CNL-15-170

Watts Bar Nuclear Plant, Unit 1
Facility Operating License No. NFP-90
NRC Docket No. 50-390

Subject: **Responses to NRC Audit Review Questions for Watts Bar Nuclear Plant Unit 1 Essential Raw Cooling Water and Component Cooling Water System License Amendment Request**

Responses to NRC Audit Review Questions for WBN Unit 1 ERCW and CCS License Amendment Request

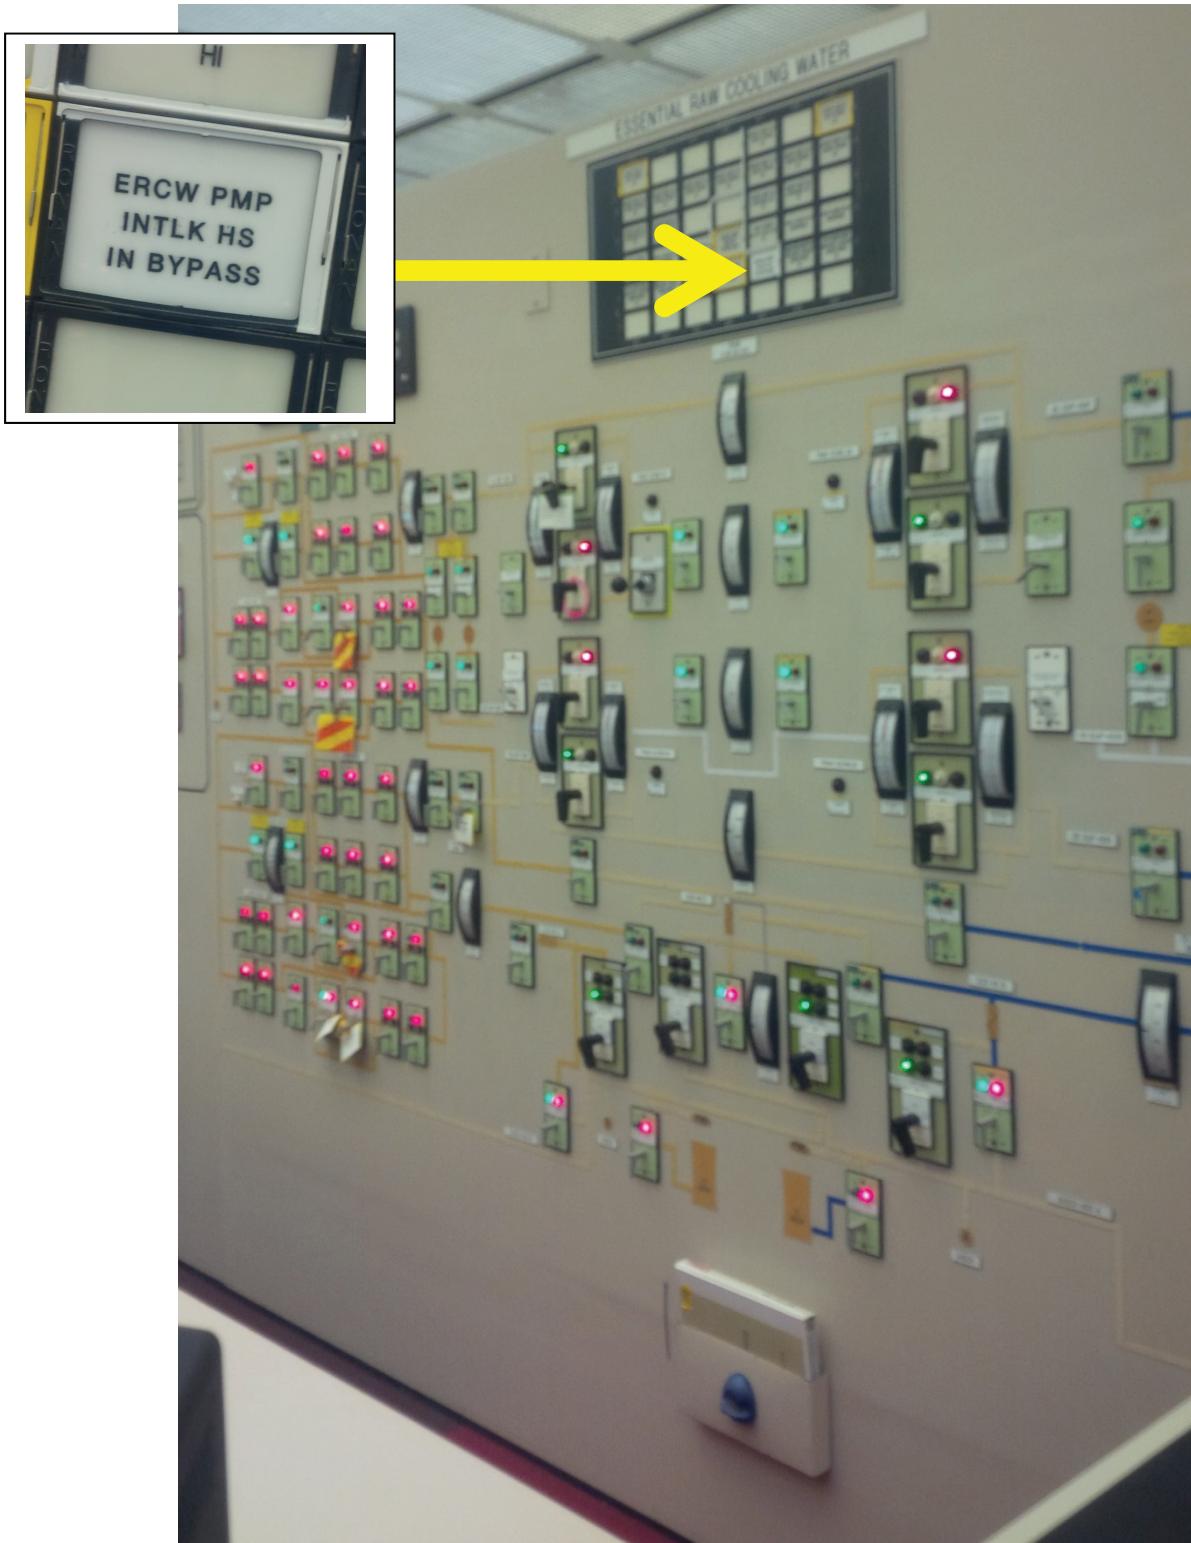
Item No.	NRC Question/Request Date Posted	TVA Response/Dated Posted
47.	SCVB-RAI-7	<p>Please confirm that Loss of train A concurrent with loss of offsite power (LOOP) during which CCS heat exchanger (HX) 'C' carries the heat load of both the LOCA and shutdown unit is the most limiting condition for the CCS fluid temperature, containment analysis parameters (containment peak pressure and temperature) and the shutdown cooling analysis. For the most limiting case of heat loads, specify at what time after initiation of shutdown cooling in the "Shutdown Unit" the LOCA is assumed to occur in the "LOCA Unit."</p> <p>TS - 2</p> <p>Please provide a more complete explanation of why Conditions B of both proposed LCO 3.7.16 and proposed LCO 3.7.17 have no effective completion, i.e. "Once per 12 hours"? Is this condition proposed to continue until the LCO expires i.e. "... 48 hours after entry into Mode 3 from Mode 1 or 2"? The current basis statement for each LCO does not adequately explain why no restoration action is needed.</p> <p>Date Posted: 08/25/15</p>

CCW HX UA		3.17		2.00
At 2718 sec Spray Recirc	spray=	22,798	BTU/sec	22,798
	RHR=	11,770	BTU/sec	10,612

There was no change in the spray heat removal rate and an approximately 10% reduction in the RHR heat removal rate. The RHR sprays are not credited in the analysis which uses W-COBRA/TRAC Mass & Energies because the calculated pressure will either not exceed 9.5 psig, or will only remain above 9.5 psig for a duration less than 3600 seconds.

Therefore, similarly on U1 the containment design is not challenged and the results are acceptable for two or three ERCW pump cases.
